Conway Planning Commission  
Staff Report

7:00pm • September 16, 2019 • 810 Parkway Avenue

# I.A REQUEST FOR PRELIMINARY PLAT APPROVAL - CAMPBELL COVE, PHASE III

# I.B REQUEST FOR PRELIMINARY PLAT APPROVAL - HUM'S HARDWARE SUBDIVISION

**CAMPBELL COVE P.U.D. PHASE 3**  
CITY OF CONWAY  
**PRELIMINARY LOT PLAN**

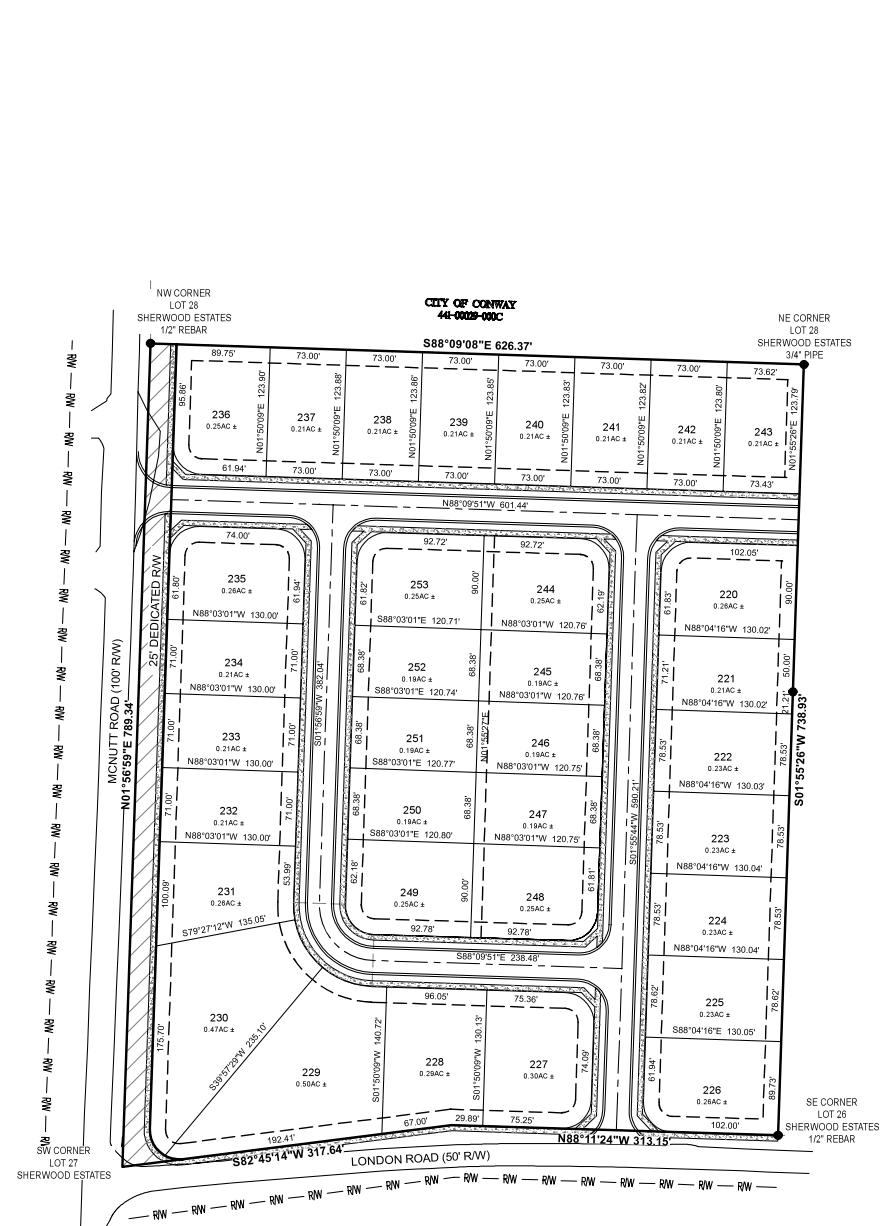
1. Show all hydrant locations.
2. Corrections as noted on Preliminary Plat.

1. Approval of the requested rezoning to R-2 shall be obtained from City Council prior to receiving authorization to proceed with construction.
2. Preliminary Plat approval from all reviewing agencies shall be obtained.
3. A draft of any Bill of Assurance proposed for the subdivision generally describing proposed covenants, restrictions and conditions applicable to the property included in the submitted plat.
4. Fire hydrants must be placed so that the furthest point of a lot in a residential subdivision is not more than 600 feet from the hydrant located on the same street. Variances must be approved by the Planning Commission and Fire Chief.
5. Minimum clearance of twenty-six (26) feet must be provided around a fire hydrant.
6. Utility easements as required by Conway Corporation are needed.

7. Drainage easements as required by the City Engineer are needed.
8. All other applicable provisions of the City of Conway Subdivision Ordinance (O-00-03) shall be satisfied and accounted for prior to Preliminary Plat approval.
9. Receipt of an approved or conditionally approved copy of the Preliminary Plat, together with an approved copy of the Improvements Plan shall constitute authorization of the Planning Commission for the developer to proceed with the preparation of the Final Plat, the installation of improvements, and the staking out of lots and blocks. The developer, after conditional approval of the Preliminary Plat, shall complete all improvements required under this regulation.

Project No.: 035628  
Issued: AUG. 29, 2019  
Drawn By: JGB  
Checked By: BCD  
Scale: 1" = 40'  
Sheet Title: PRELIMINARY PLAT  
Sheet Number:

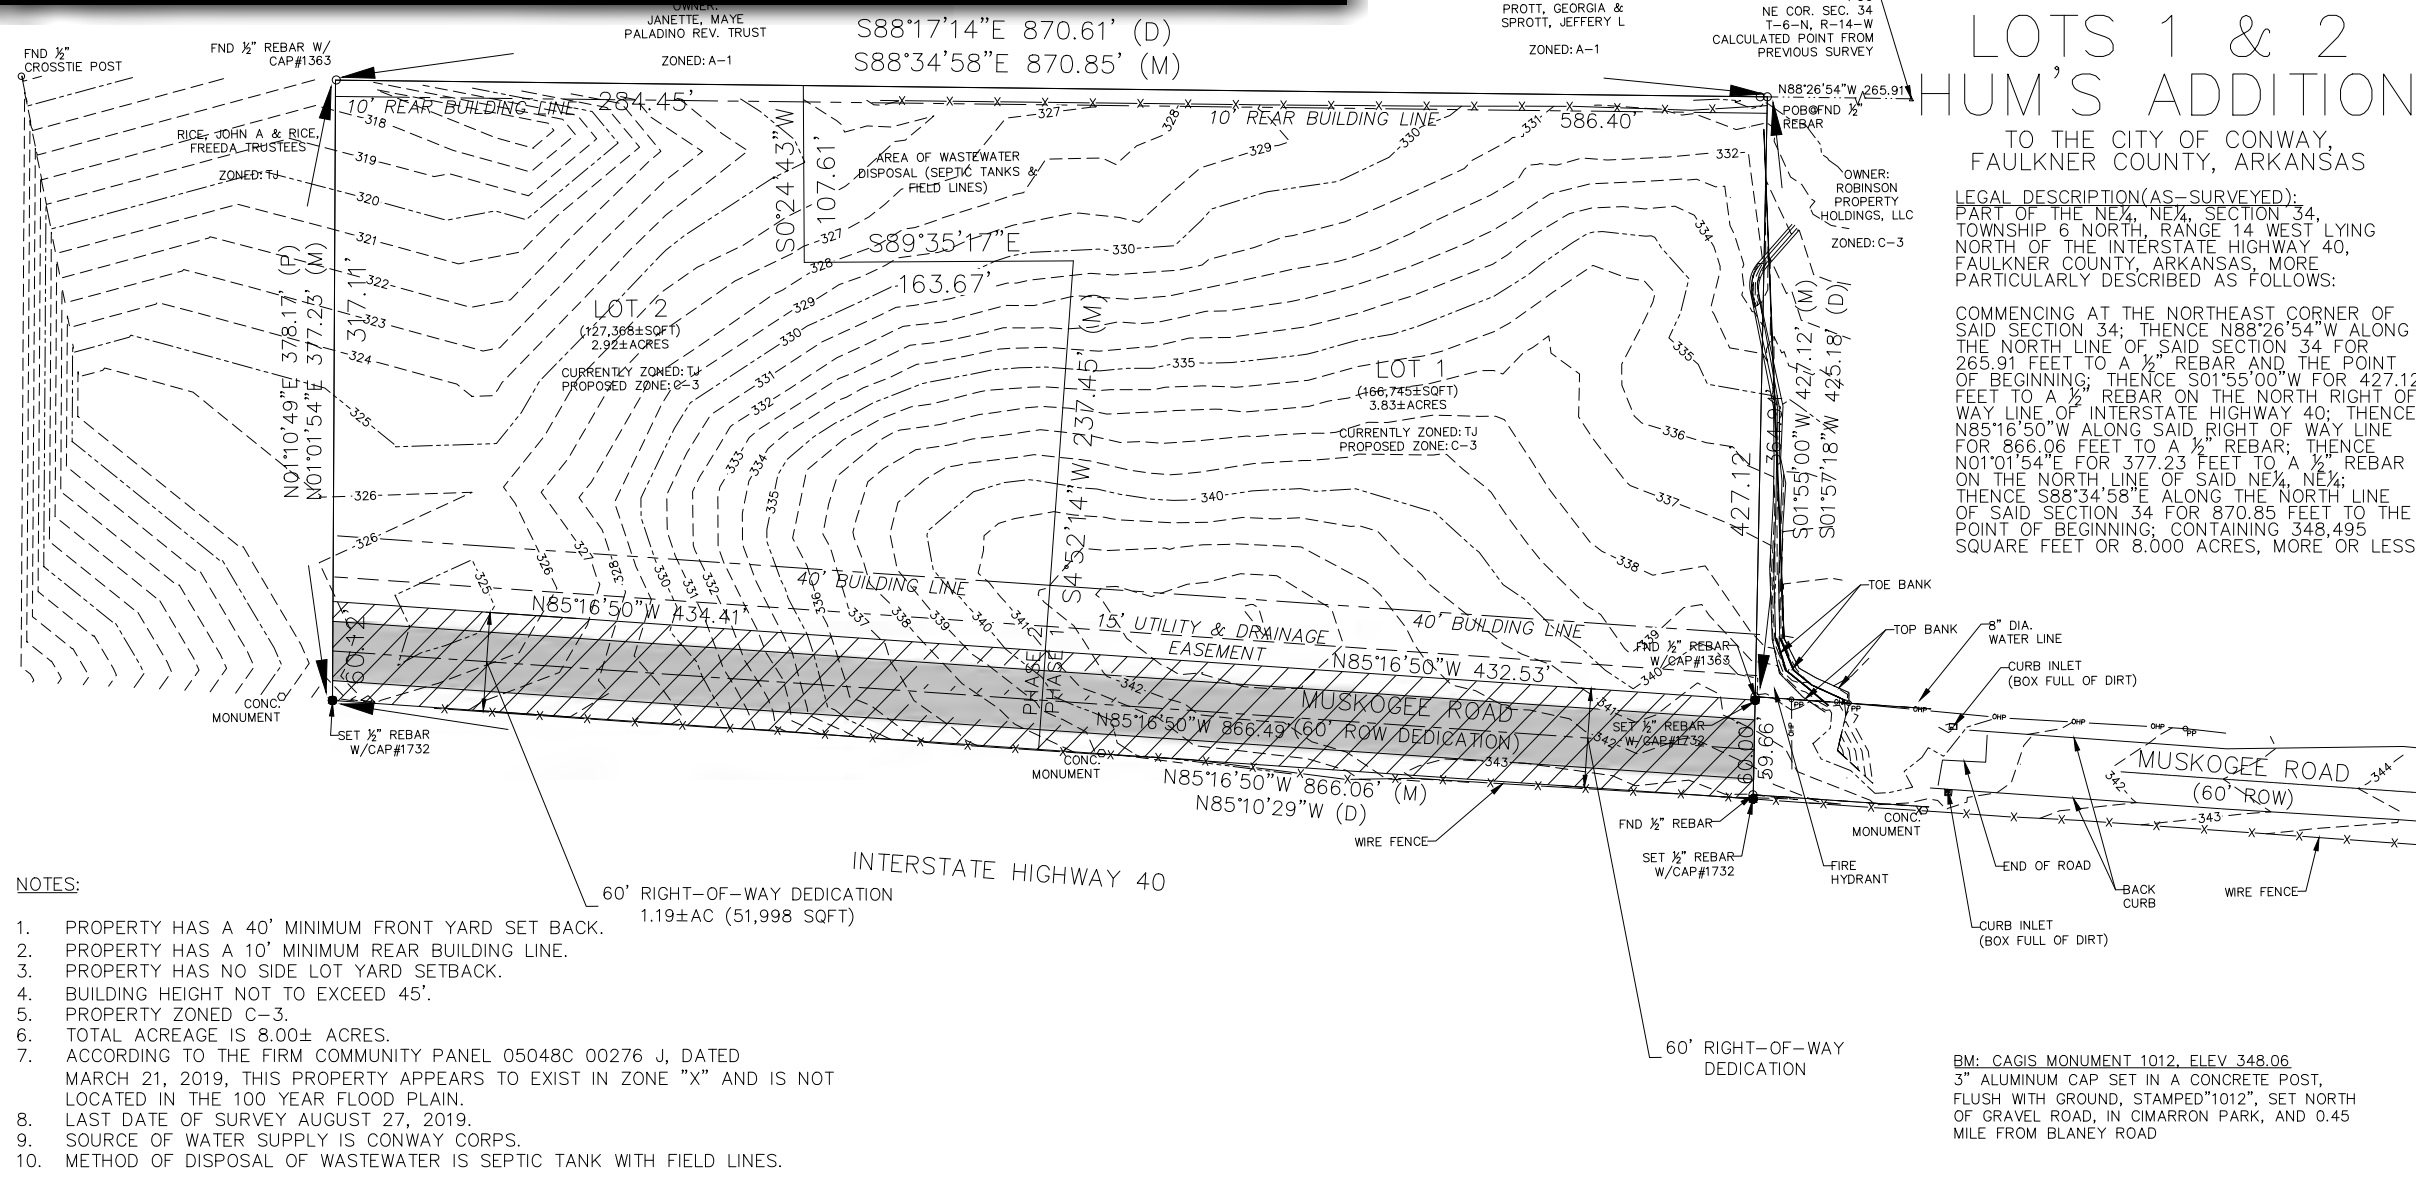
1. Show all hydrant locations.
2. Corrections as noted on Preliminary Plat.
3. Department of Health shall approve all Septic Systems prior to filing final plat

1. Preliminary Plat approval from all reviewing agencies shall be obtained.
2. Approved improvement plans for each new utility system shall be obtained prior to submission of final plat and authorization to proceed.
3. A draft of any Bill of Assurance proposed for the subdivision generally describing proposed covenants, restrictions and conditions applicable to the property included in the submitted plat.
4. State Fire Code 503.0.5 states that dead-end fire apparatus access roads in excess of 150 feet in length shall be provided with an approved area for turning around fire apparatus. Anything other than the following cul-de-sac requirement must be approved by the Conway Fire Marshall. *Preliminary Plat Approval conditioned upon Fire Department approval of access and turn around requirements for new street.*

- Minimum clearance of twenty-six (26) feet must be provided around a fire hydrant.
- Utility easements as required Conway Corporation are needed.
- Drainage easements as required by the City Engineer are needed.
- All other applicable provisions of the City of Conway Subdivision Ordinance (O-00-03) shall be satisfied and accounted for prior to Preliminary Plat approval.
- Receipt of an approved or conditionally approved copy of the Preliminary Plat, together with an approved copy of the Improvements Plan shall constitute authorization of the Planning Commission for the developer to proceed with the preparation of the Final Plat, the installation of improvements, and the staking out of lots and blocks. The developer, after conditional approval of the Preliminary Plat, shall complete all improvements required under this regulation.

# ORCHARD HILLS SUBDIVISION PHASE I

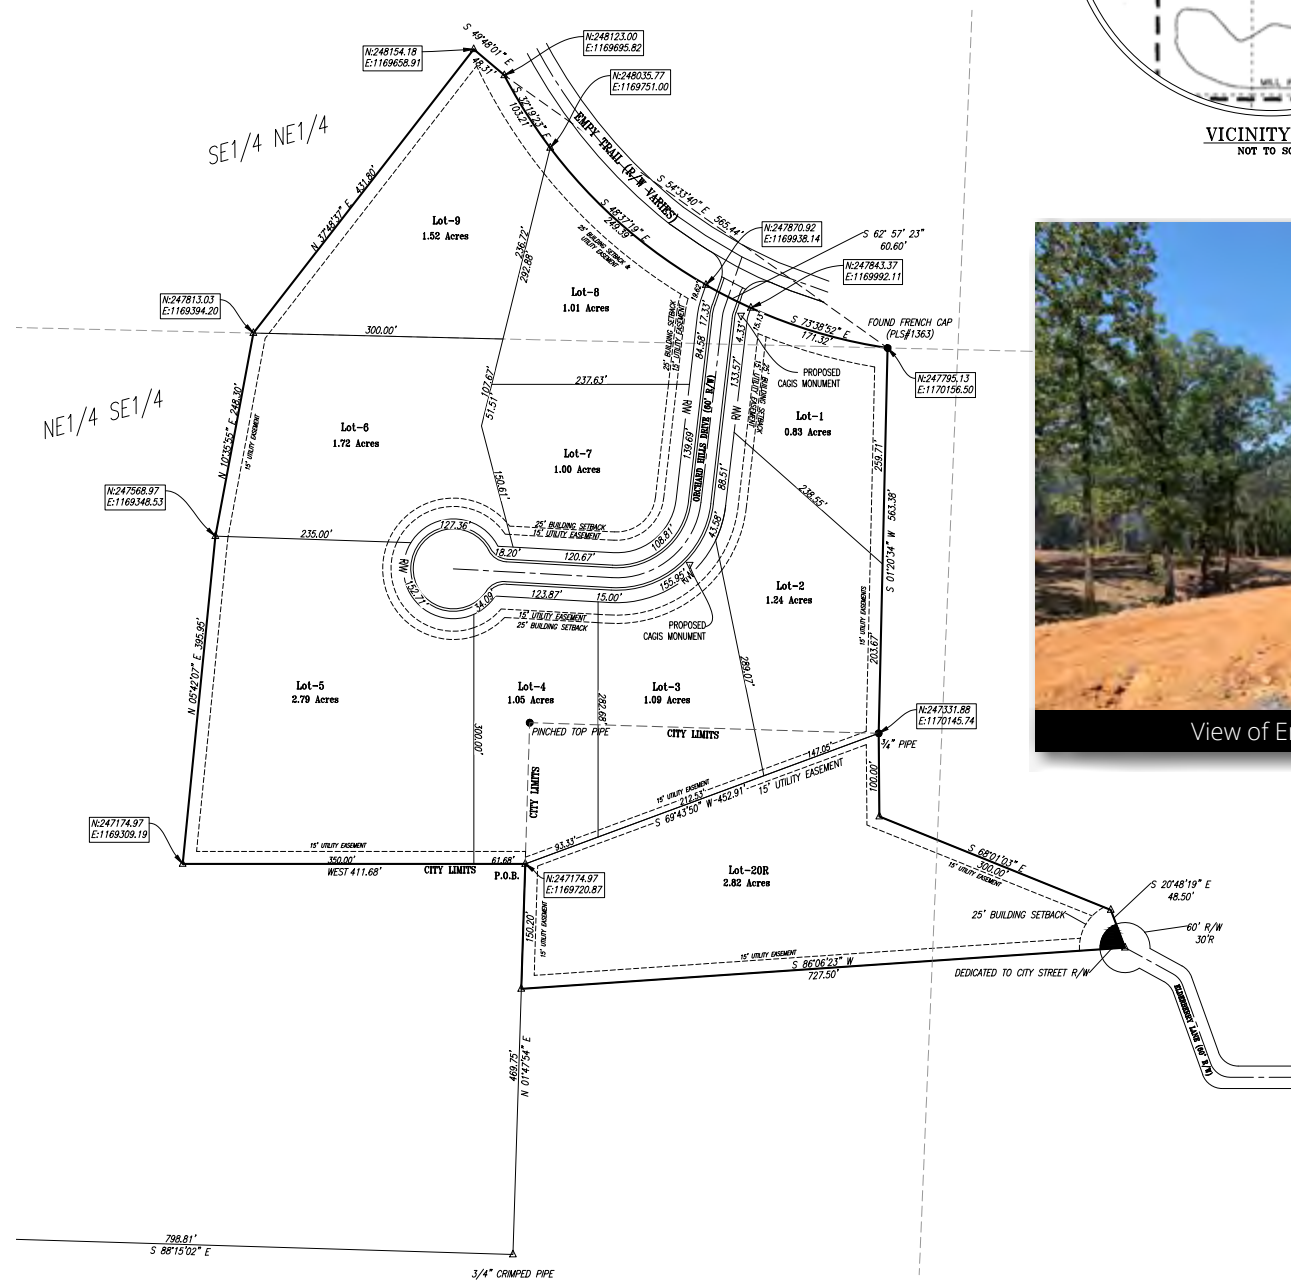
1. Show all hydrant locations.
2. Corrections as noted on Preliminary Plat.
3. Department of Health shall approve all Septic Systems prior to filing final plat.

- Adjust lot lines as necessary to accommodate a minimum lot area of 1 acre and minimum street frontage requirement of 150 feet for all lots. Lot 20-R shall be exempt from the frontage requirement as it's existing platted frontage length is not proposed to change.

- State Fire Code 503.0.5 states that dead-end fire apparatus access roads in excess of 150 feet in length shall be provided with an approved area for turning around fire apparatus. Anything other than the following cul-de-sac requirement must be approved by the Conway Fire Marshall. *Preliminary Plat Approval conditioned upon Fire Department approval of access and turn around requirements for new street.*

- Fire hydrants must be placed so that the furthest point of a lot in a residential subdivision is not more than 600 feet from the hydrant located on the same street. Variances must be approved by the Planning Commission and Fire Chief.

SHEET No.  
**2.0**

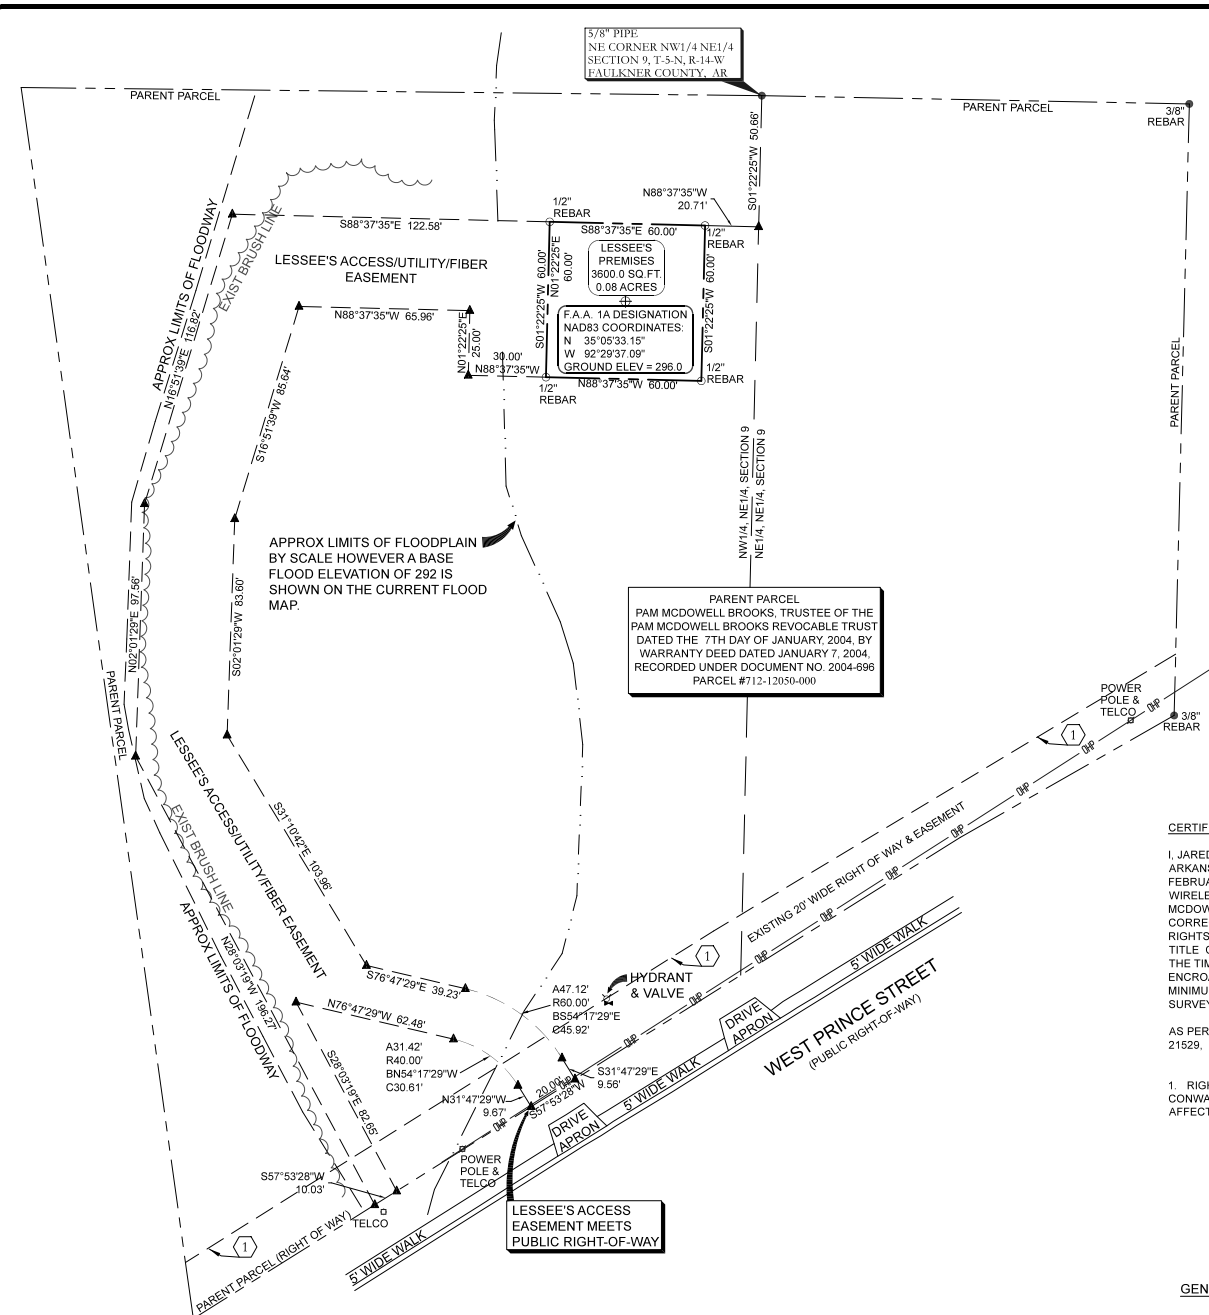
**Height.** Tower height shall be limited to 150 feet maximum as measured from average undisturbed soil area to the highest tower projection. The City Council reserves the right to limit tower height for any given location to the most appropriate height. *The code allows up to 150 feet. The requested tower is 150 feet.*

**Setbacks.** Transmission towers shall be setback a distance equal to the tower's height from the property line or any occupiable structure. If the Applicant provides a letter or design drawings stamped by a certified structural engineer documenting that the proposed structure's fall zone is less than the actual height of the structure, the setbacks shall be reduced to applicable structure setbacks per zoning district. Accessory equipment must conform to the setback standards of the applicable zone. *The transmission tower will have a fall zone of 75 feet. All setbacks except the rear setback are proposed to exceed the height of the proposed tower. The rear setback is proposed to be 80 feet.*

**Fencing.** Ground mounted accessory equipment and support structures shall be secured and enclosed with a fence not less than 6 feet in height. If the tower location is within view of a public right of way, or an aesthetically sensitive area, fence shall be made of a durable material appropriate for the development and/or area. Brick or masonry shall be the preferred materials. Lesser material shall be appropriate for non-aesthetically sensitive areas. *The tower enclosure is proposed to be fenced with a 6 foot tall brick faced wall.*

**Landscaping.** If the tower location is viewable from a public right of way, or otherwise located in an aesthetically sensitive area, landscaping shall be required surrounding the fencing of accessory equipment. Required landscaping shall be consistent with surrounding vegetation and shall be maintained by the facility owner. The City Council may choose to not require landscaping for sites that are not visible from the public right-of-way or adjacent property or in instances where in the judgment of the City Council, landscaping is not appropriate or necessary. *The applicant is proposing 6 Holly trees with a 6' planting height and 20 Gold Coast Juniper evergreen shrubs.*

1. Obtain proper floodplain permit prior to construction.
2. Require concrete paving of the driveway.
3. Construct the transmission tower as submitted in the plans. Changes to the plan shall require reapproval by the Planning Commission.
